Office Action Summary	Application No. 10/714,935	Applicant(s) MAEDA ET AL.	
	Examiner JIMMY H. NGUYEN	Art Unit 2629

DETAILED ACTION

1. This Office Action is made in response to applicant's amendment filed on 02/12/2009. Claims 1-3, 8-18, 20-25 and 29-33 are currently pending in the application. An action follows below:

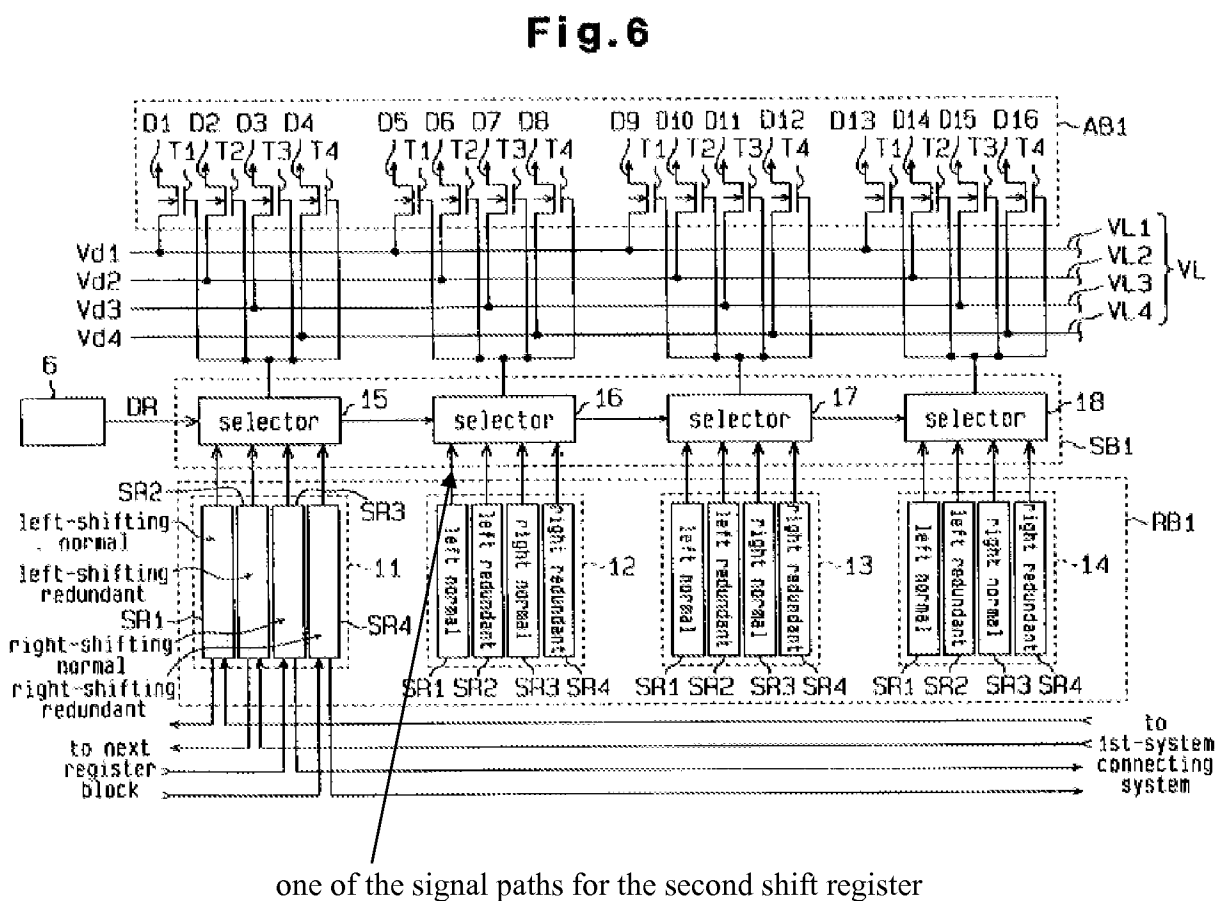
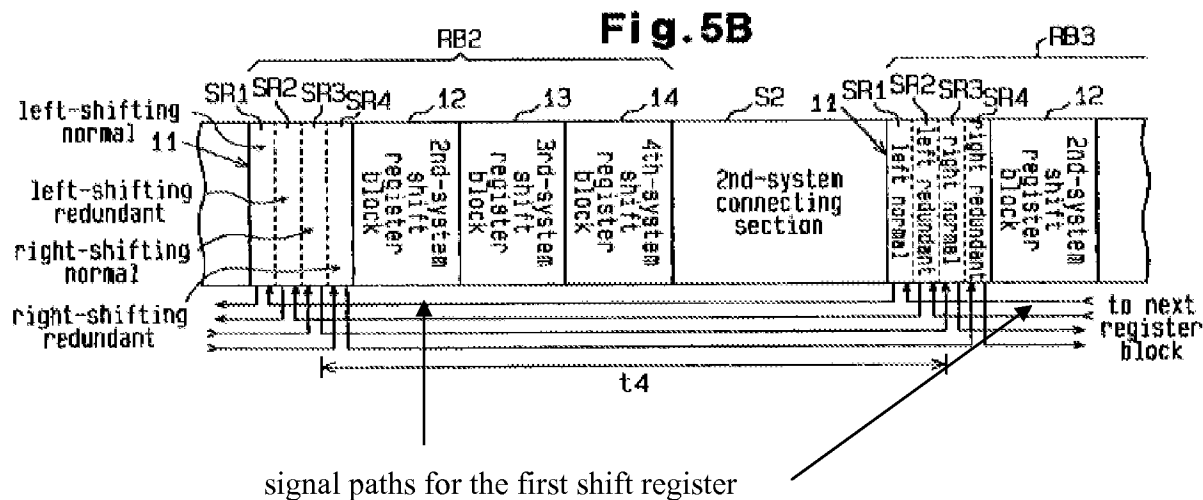
propagating a second input signal therethrough in response to a second clock signal (CK2) (Fig. 8; col. 5, line 57 through col. 6, line 23); wherein the second unit circuits (SR1 of the second register groups 12), as also being the claimed first circuits, are linearly aligned with the first unit circuits (SR1 of the first register groups 11) and the second unit circuits (SR1 of the second register groups 12) are disposed in physical spaces between the first unit circuits (SR1 of the first register groups 11) (see Figs. 4-6).

Regarding to the limitation, “signal paths for the first and second shift registers are provided separately for each of the first and second shift registers on respective sides of a circuit alignment of the first and second unit circuits of the first and second shift registers” (see lines 12-14 of claim 1), Kihara discloses that the signal paths (the paths connecting the left-shifting normal register SR1 to the next left-shifting normal register of the first shift register groups 11; see the below annotated Fig. 5B) for the first shift registers (left-shifting normal registers SR1 of the first shift register groups 11; Figs. 5A-5B, 6) are provided on the **bottom** of the circuit alignment of the unit circuits of the first and second shift registers (Fig. 5A, 5B) and the (output) signal paths for the second shift registers (left-shifting normal registers SR1 of the second shift register groups 12; see the below annotated Fig. 6) are provided on the **top** of a circuit alignment of the unit circuits of the first and second shift registers (see the below annotated Fig. 6).

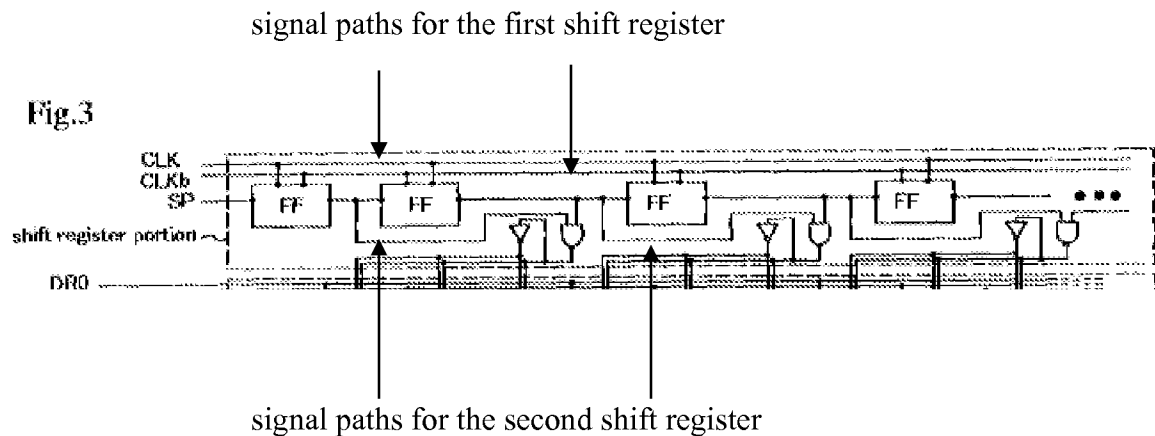
Azami teaches the first shift register comprising **4 first unit circuits** (4 FF circuits) spaced-apart cascade-connected; outputting an input signal (a start pulse SP; see Fig. 3) in response to a clock signal (CLK; see Fig. 3, col. 6, lines 64-67); and sequentially outputting a selection signal from output-stages comprised of the unit circuits (see Fig. 3, col. 6, lines 64-67). Azami further teaches the first unit circuits (FF circuits) of the first shift register being linearly disposed so that physical spaces are provided between adjacent pairs of the unit circuits (see Fig. 3).

Regarding to the limitation, “signal paths for the first and second shift registers are provided separately for each of the first and second shift registers on respective sides of a circuit alignment of the first and second unit circuits of the first and second shift registers” (see lines 12-14 of claim 1), Azami teaches the signal paths for the first shift register (paths for transmitting clock signals to each FF circuit of the first shift register; see the below annotated Fig. 3) provided on the **top side** of a circuit alignment of the unit circuits of the first and second shift registers and the signal paths for the second shift register (paths for transmitting the output signals from the inverters and NAND gates to the first latch portion; see the below annotated Fig. 3) provided on

the **bottom side** of a circuit alignment of the unit circuits of the first and second shift registers
(see the below annotated Fig. 3).

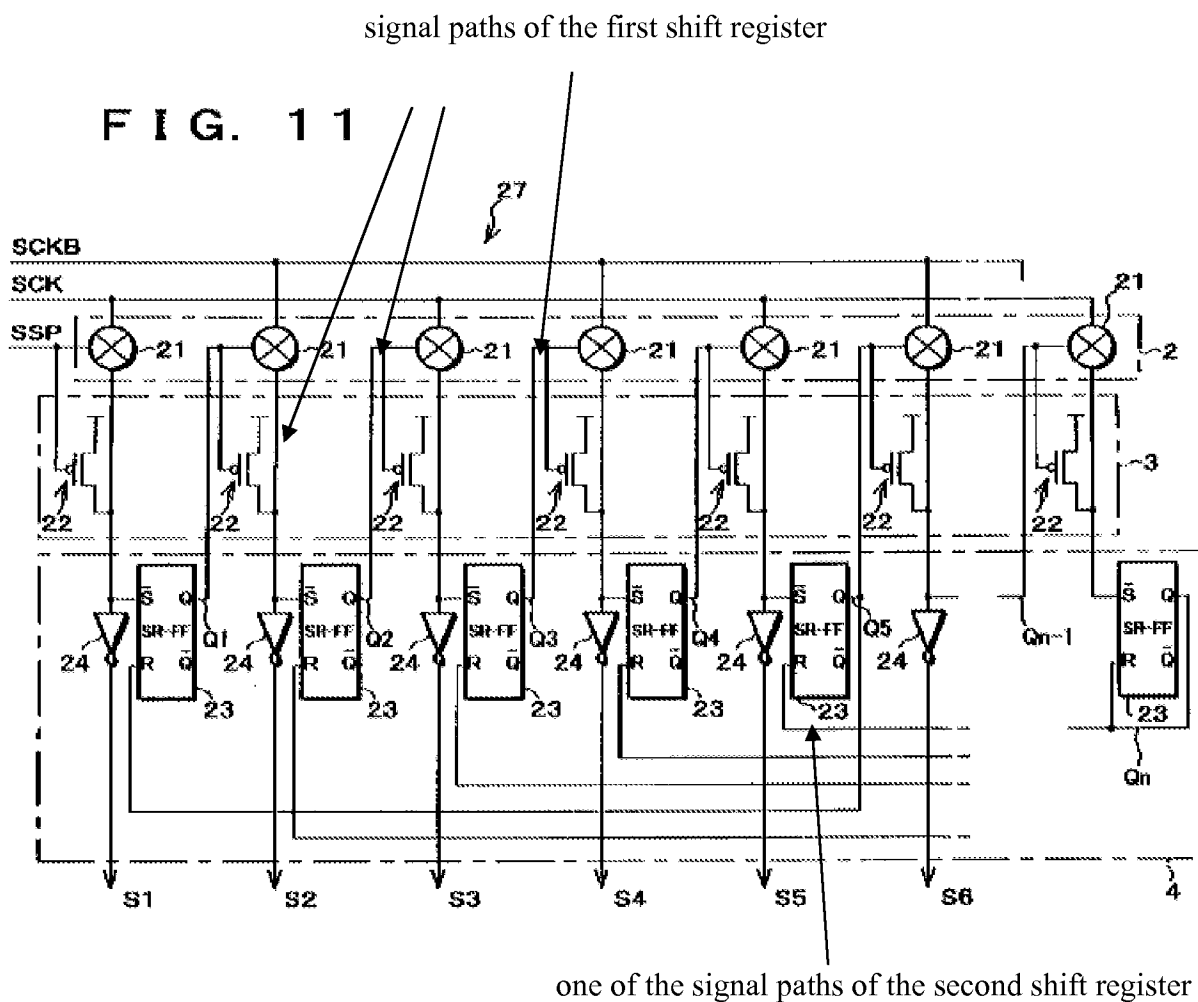
Washio teaches the first shift register comprising **4 first unit circuits** (4 FFs 23) spaced-apart cascade-connected; outputting an input signal (a signal inputted in S terminal of the first FF 23; see Fig. 11) in response to a clock signal (SCK/SCKB; see Fig. 11, col. 12, lines 55-67); and sequentially outputting a selection signal from output-stages comprised of the unit circuits (23) (see Fig. 11, col. 15, line 59 through col. 16, line 21). Washio further teaches the first unit circuits (FFs 23) of the first shift register being linearly disposed so that physical spaces are provided between adjacent pairs of the unit circuits (23) of the first shift register (see Fig. 11). Washio further teaches **first circuit** (each circuit including an inverter 24 and its connections; see Fig. 11) different from the first unit circuits (23) of the first shift register, disposed in the physical spaces between adjacent unit circuits (23), and having outputs, which are not supplied to any of the unit circuits (23) of the first shift register (see Fig. 11). Note that the first circuit (24) is considered as the claimed second unit circuit for the second shift register (a second shift register comprising next 4 FFs 23 and inverters 24 associated with the first four FF circuits; see Fig. 11).

Regarding to the limitation, “signal paths for the first and second shift registers are provided separately for each of the first and second shift registers on respective sides of a circuit alignment of the first and second unit circuits of the first and second shift registers” (see lines 12-14 of claim 1), Washio teaches the **signal paths** for the first shift register (paths for transmitting set signals to Sbar terminals to the first four FFs 23 or output signals Q from the first four FFs 23; see the below annotated Fig. 11) provided on the **top side** of a circuit alignment of the unit

circuits of the first and second shift registers and **signal paths** for the second shift register (paths for transmitting the reset signals R to the R terminal of the next 4 FFs of the second shift register; see the below annotated Fig. 11) provided on the **bottom side** of a circuit alignment of the unit circuits of the first and second shift registers (see the below annotated Fig. 11).
